ATTACHMENT 3

PROPOSED ENVIRONMENTAL TECHNICAL SPECIFICATION CHANGE

NORTH ANNA UNITS 1 AND 2

FIGURE 5.2-1
ORGANIZATION CHART
ENVIRONMENTAL TECH SPEC IMPLEMENTATION

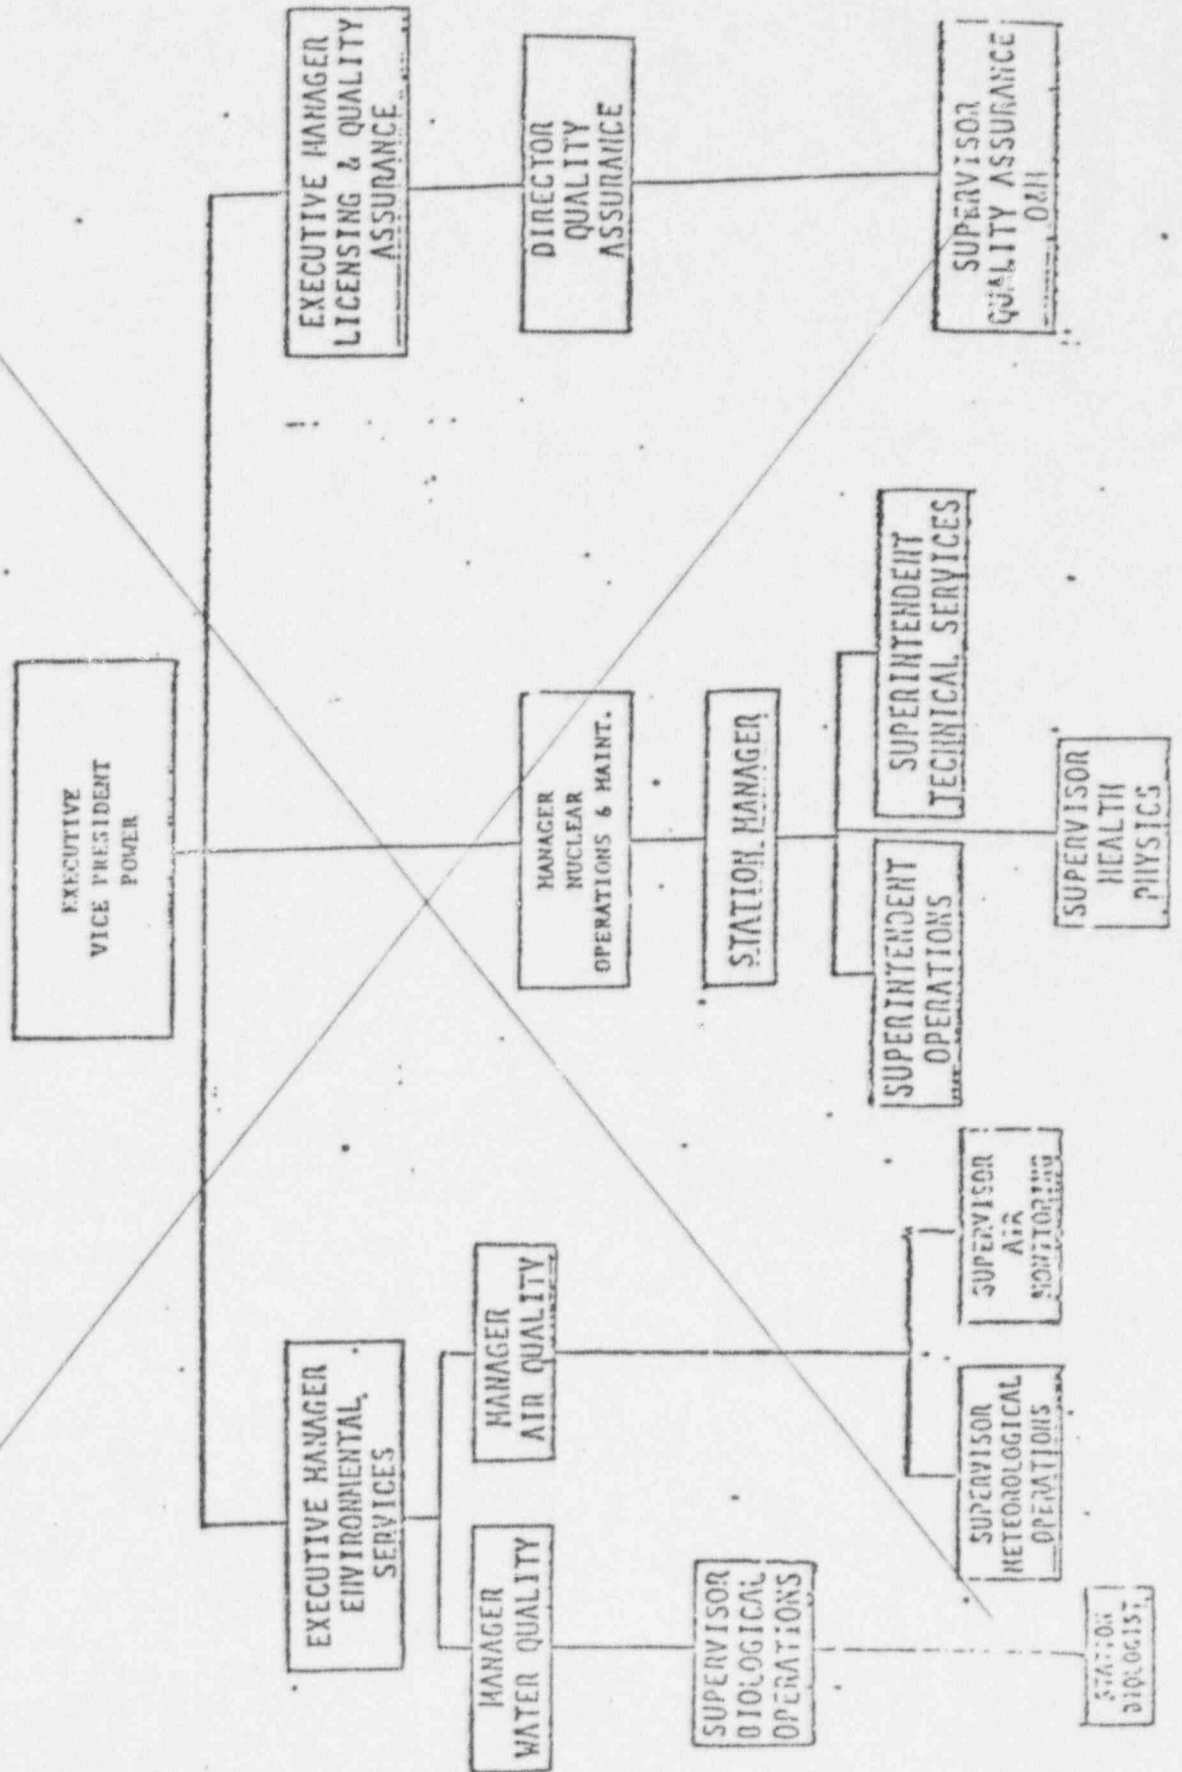
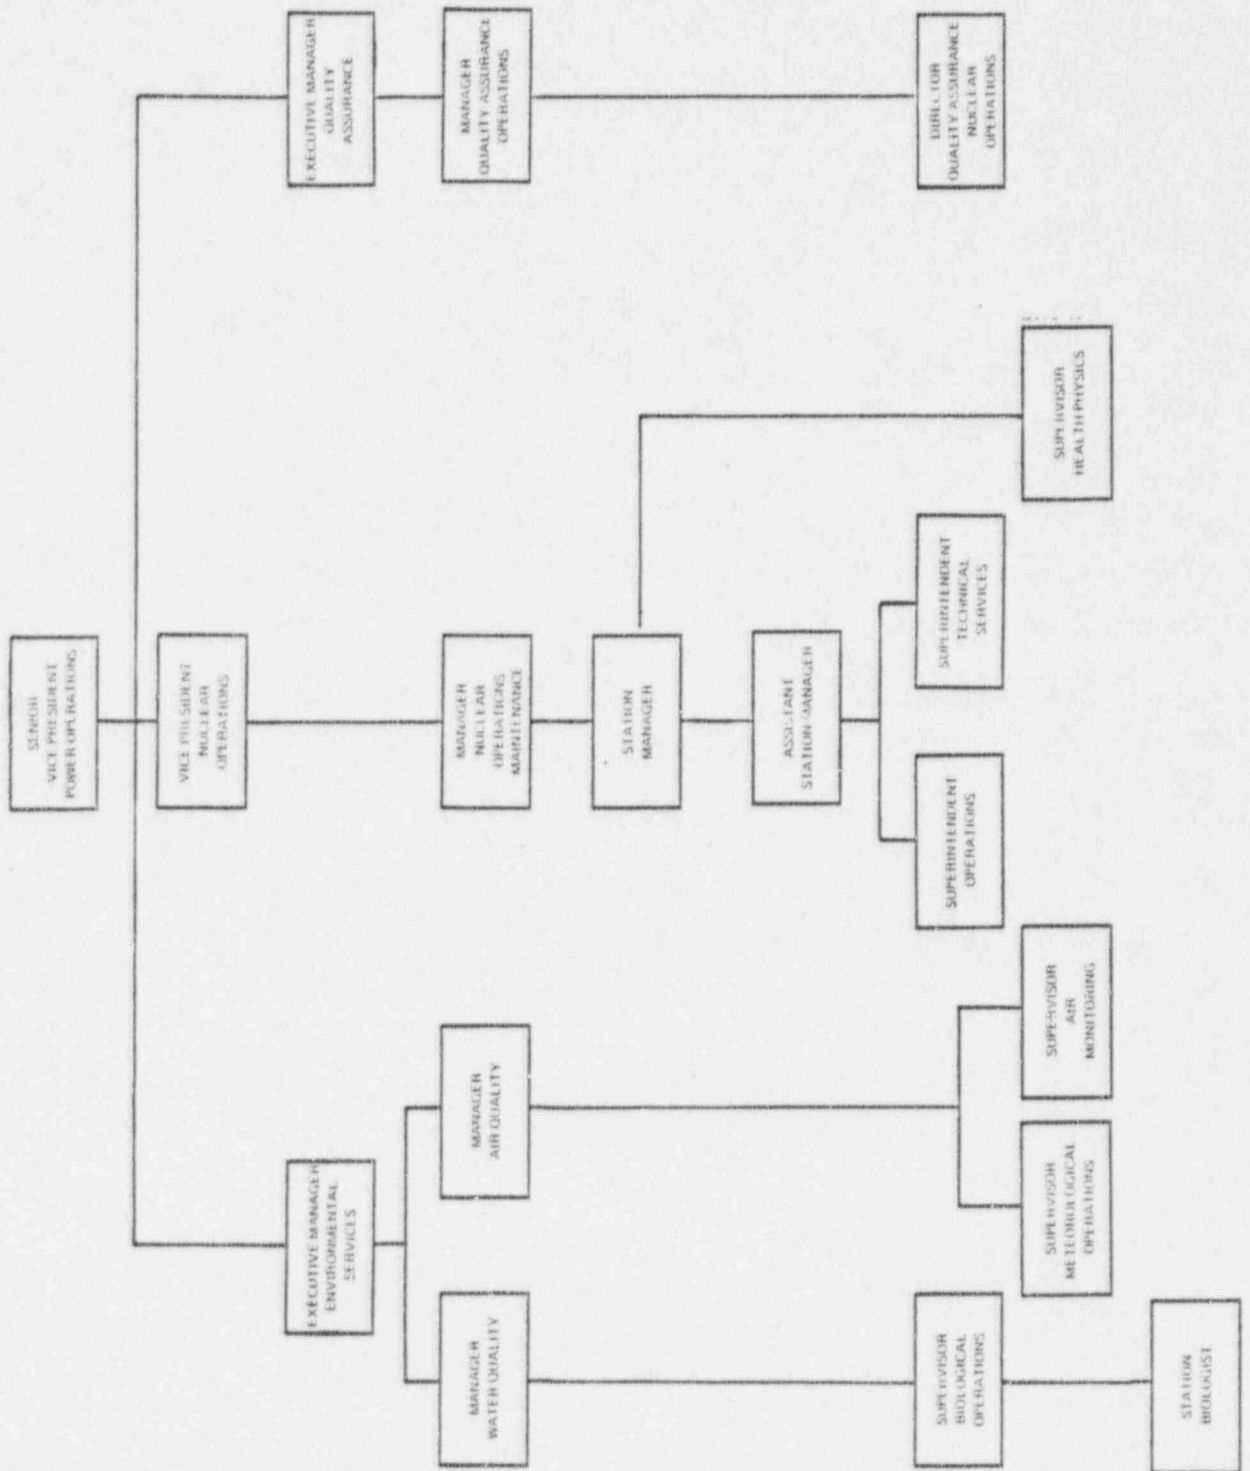
The organization charts for the North Anna Environmental Technical Specifications and the Appendix "A" Technical Specifications have been revised to reflect the restructuring of the Quality Assurance Department and changes to other organization titles. The previous title of Executive Manager-Licensing and Quality Assurance has been revised to Executive Manager-Quality Assurance. In addition, the positions of Manager-Quality Assurance, Operations and Director-Quality Assurance, Nuclear Operations are shown on the organization chart; however, those positions of the Quality Assurance Department which have no direct responsibility pertaining to the operation of the nuclear stations have not been shown on the Technical Specifications organization chart or referenced in the text of the Specifications.
